Regulation No. 125 (Forward field of vision of drivers)

Proposal for amendments to Regulation No. 125

Submitted by the expert from Japan*

Figure

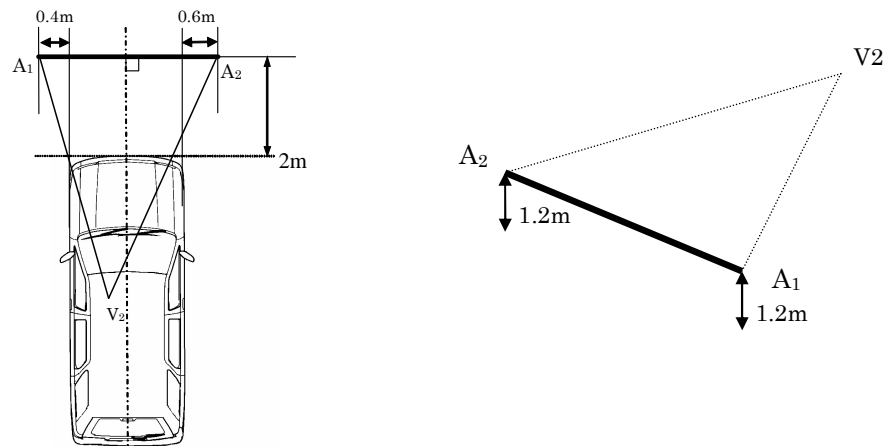
Other than the obstructions created by the A pillars, outside radio aerials, mirrors and windscreen wipers, there should be no obstruction in a plane passing through the three points A1, A2, and V2, where A1 is a point 0.4 m outside of the outermost edge of the vehicle on the driver's side on a line parallel to the horizontal plane and perpendicular to the central axis of the vehicle and situated 2 m in front of the foremost edge of the vehicle and 1.2 m above ground, and A2 is a point 0.6 m outside of the outermost edge on the other side of the vehicle on the said line.

2. For vehicles with high ground clearances, V2 is also high, which means it is not always possible for the driver to perceive small vehicles in front, such as motorcycles, that come below the plane 4 degrees below V2. This new provision will enable the forward field of vision to be ensured even for high-ground-clearance vehicles (see figures below).
